# Receiver Interference Tolerance (83D.3.2.2)

Ryan Latchman, Mindspeed

IEEE 802.3bm

Figure 83D-12—Interference tolerance test setup

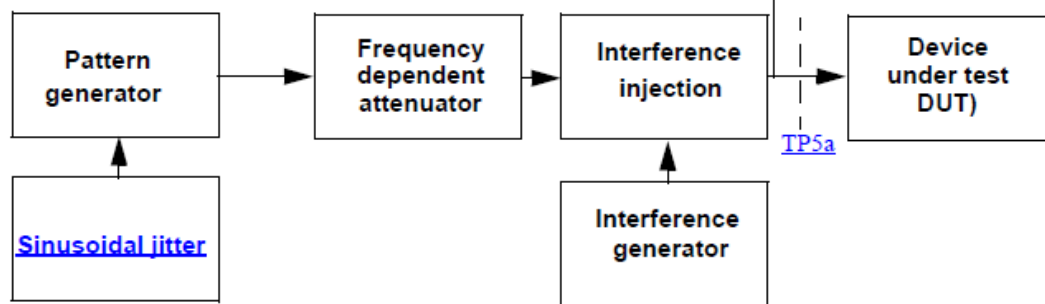
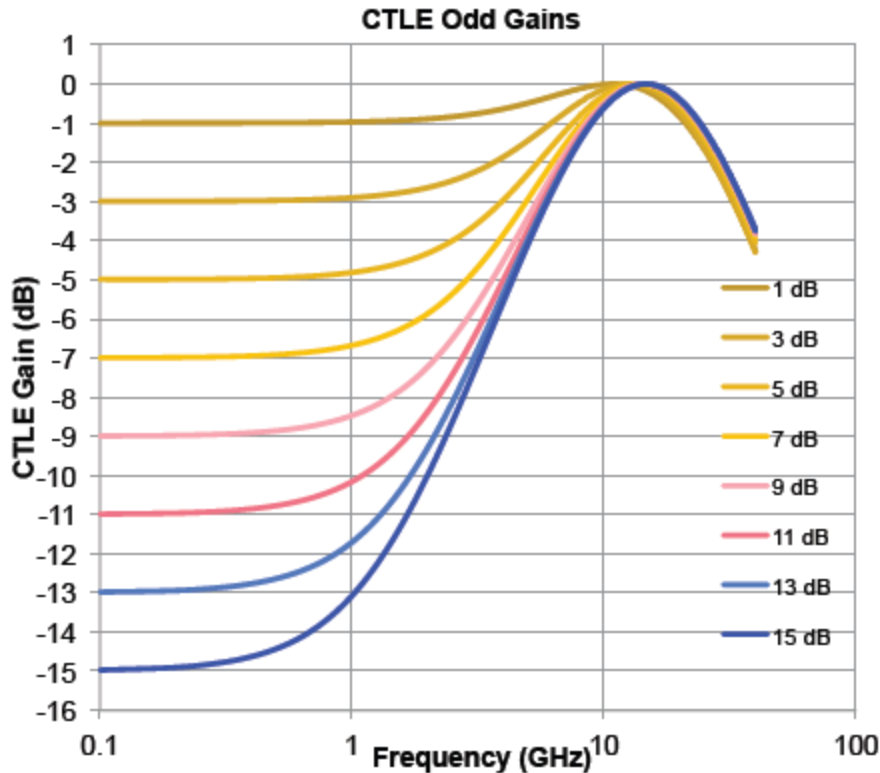
Change figure 83D-12 “frequency dependent attenuator” to “ISI channel”, change “Channel insertion loss...” to “ISI channel insertion loss”

Change figure 83D-12 to add random jitter box as an input to the pattern generator

Figure 83D-11—Selectable continuous time linear equalizer (CTLE) characteristic

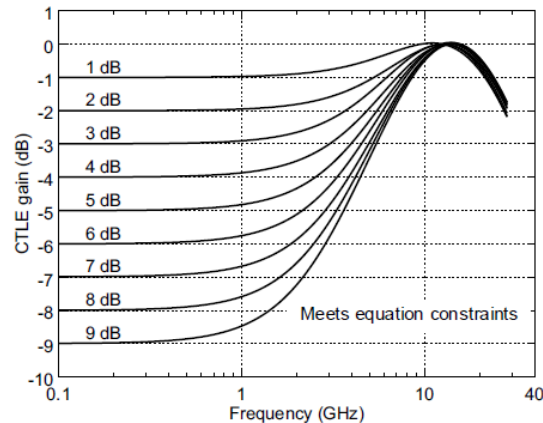
# Reference receiver CTLE update

Gain (dB)	G (Linear)	Z (GHz)	P1 (GHz)	P2 (GHz)
1	0.89125	8.3640e9	1.86e10	1.41e10
2	0.79433	7.0990e9	1.86e10	1.41e10
3	0.70795	5.6760e9	1.56e10	1.41e10
4	0.63096	4.9601e9	1.56e10	1.41e10
5	0.56234	4.3580e9	1.56e10	1.41e10
6	0.50119	3.8440e9	1.56e10	1.41e10
7	0.44668	3.3990e9	1.56e10	1.41e10
8	0.39811	3.0120e9	1.56e10	1.41e10
9	0.35481	2.6720e9	1.56e10	1.41e10
10	0.31623	2.3728e9	1.56e10	1.41e10
11	0.28184	2.1090e9	1.56e10	1.41e10
12	0.25119	1.8755e9	1.56e10	1.41e10
13	0.22387	1.6690e9	1.56e10	1.41e10
14	0.19953	1.4853e9	1.56e10	1.41e10
15	0.17783	1.3225e9	1.56e10	1.41e10
